Ercoupe MEMORANDUM

SUBJECT: Fuel System Operation

ERCOUPE SERVICE BULLETIN NO. 36

SERVICE BULLETIN NO. 24B

FIG. #1

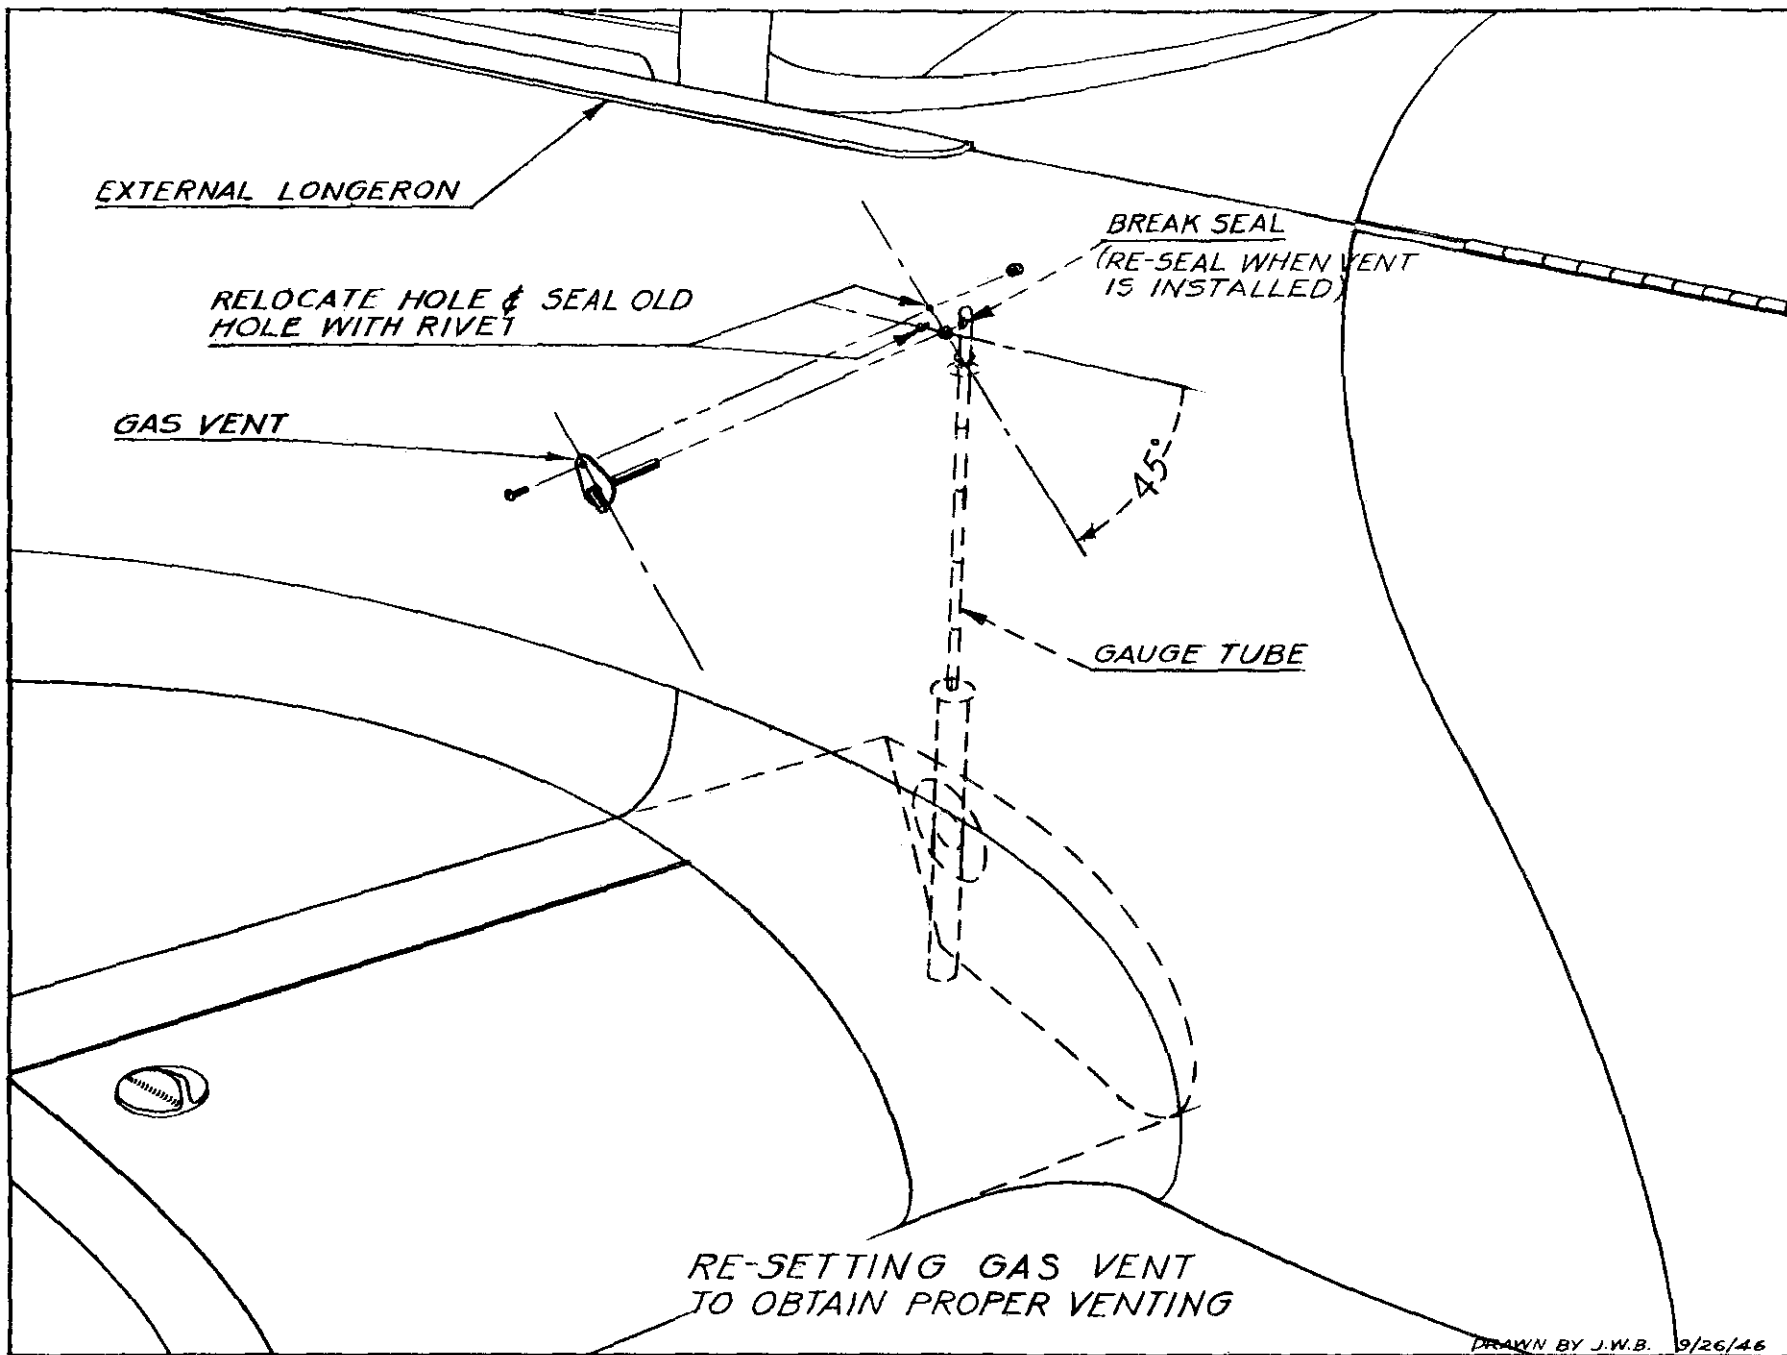
1. Remove 6 x 32 screw and nut which attaches vent to the right side of the fuselage.
2. Break the vent loose from the gage tube by turning the vent.
3. Realign the vent, by lowering the forward end, until it lies in a position from 40° to 45° with relation to the external longeron.
4. Drill a No. 28 hole through the fuselage skin, using the vent plate as a guide.
5. Insert the same 6 x 32 screw that was removed in operation No. 1.
6. Reseal vent to plastic gage tube by using clear nitrate dope, or any suitable cellulose cement. (See illustration No. 1.)
7. Close the original hole with a rivet.

FIG. # 2

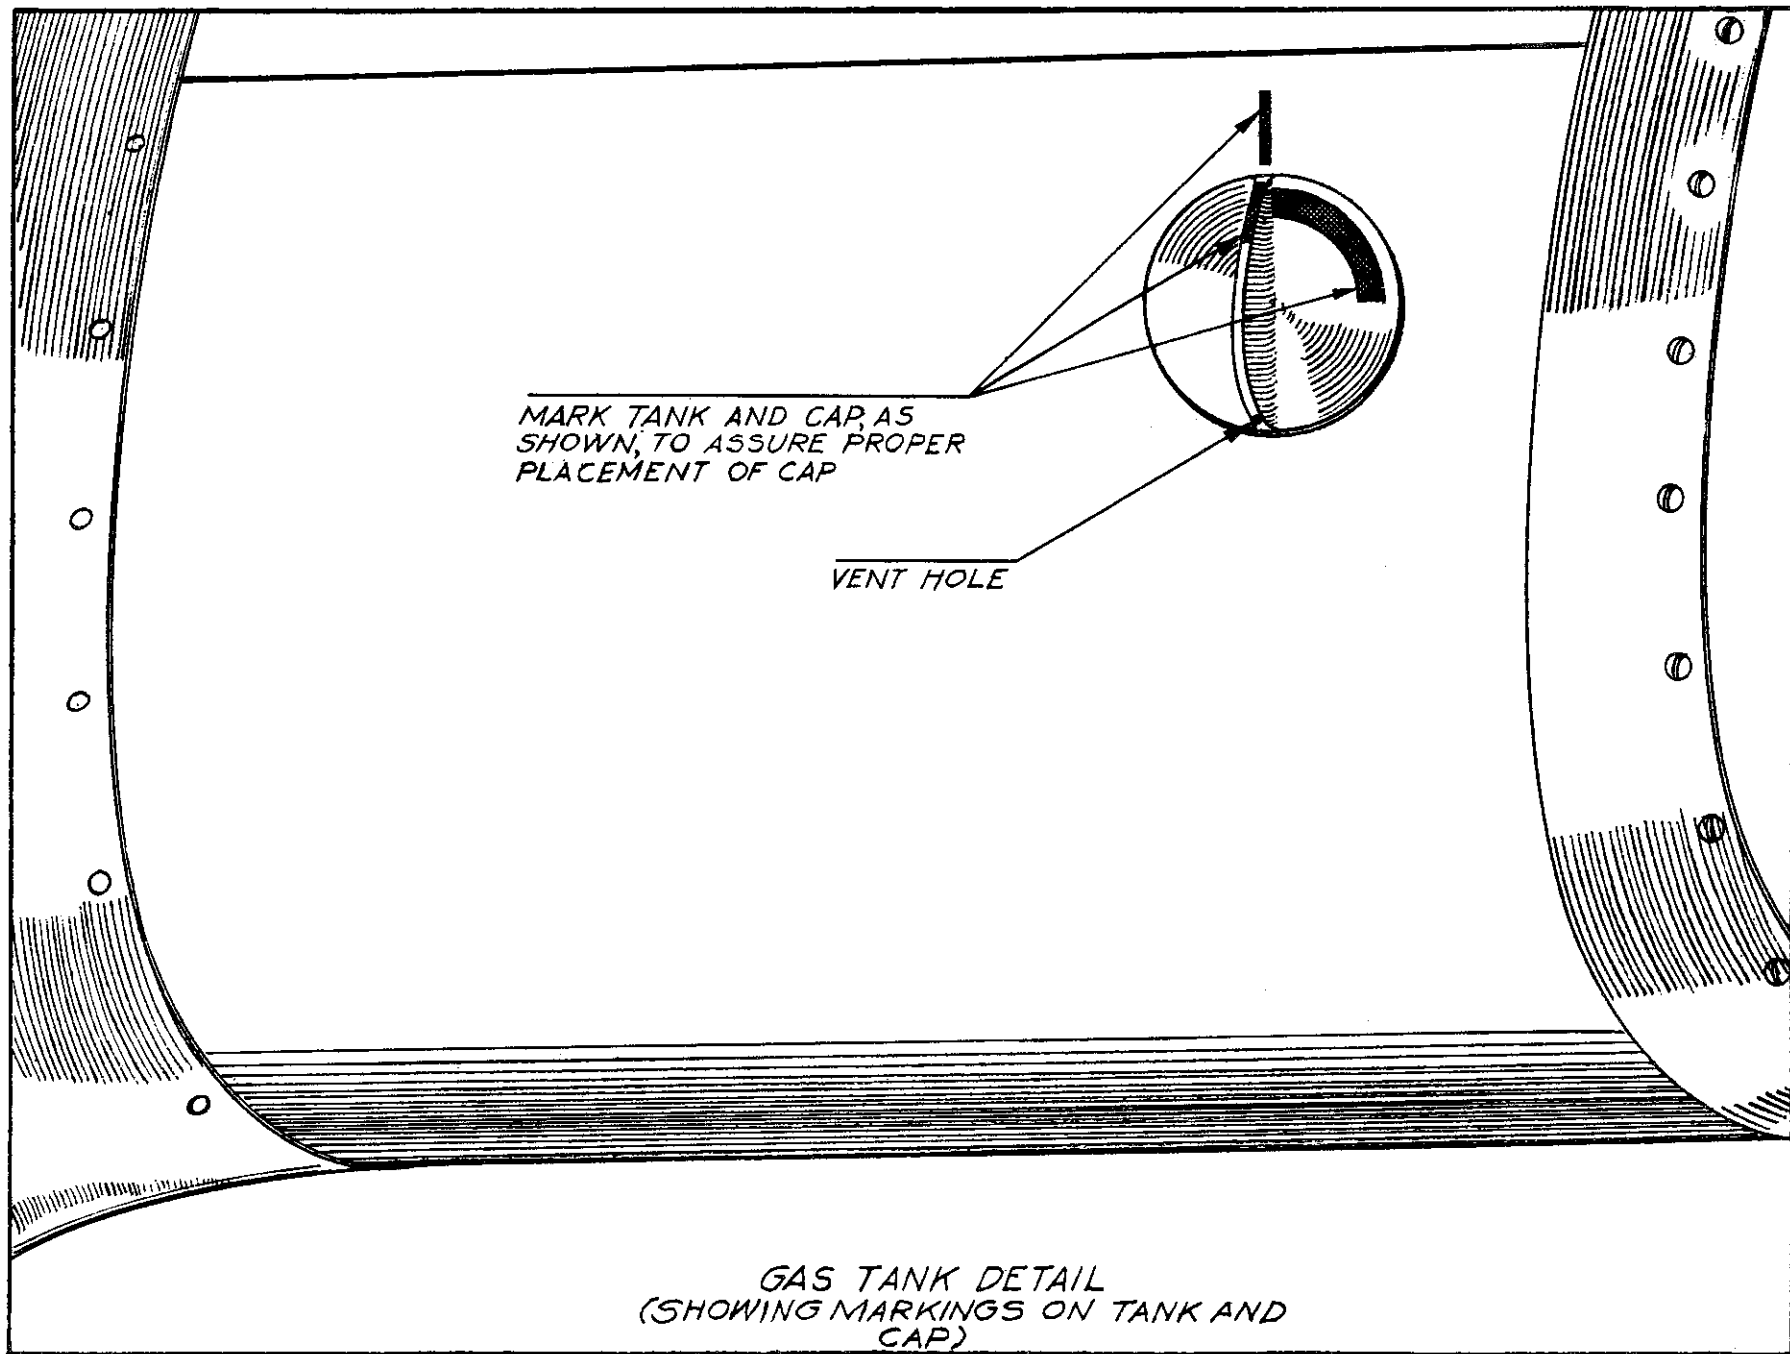
10. It is recommended that the wing tank cap be marked in a manner to indicate proper positioning. A painted red line on the wing behind the cap to match a painted sector on the cap should be used. The painted sector on the cap should extend from the point of engagement to the locked position, as indicated on accompanying sketch No. 2.
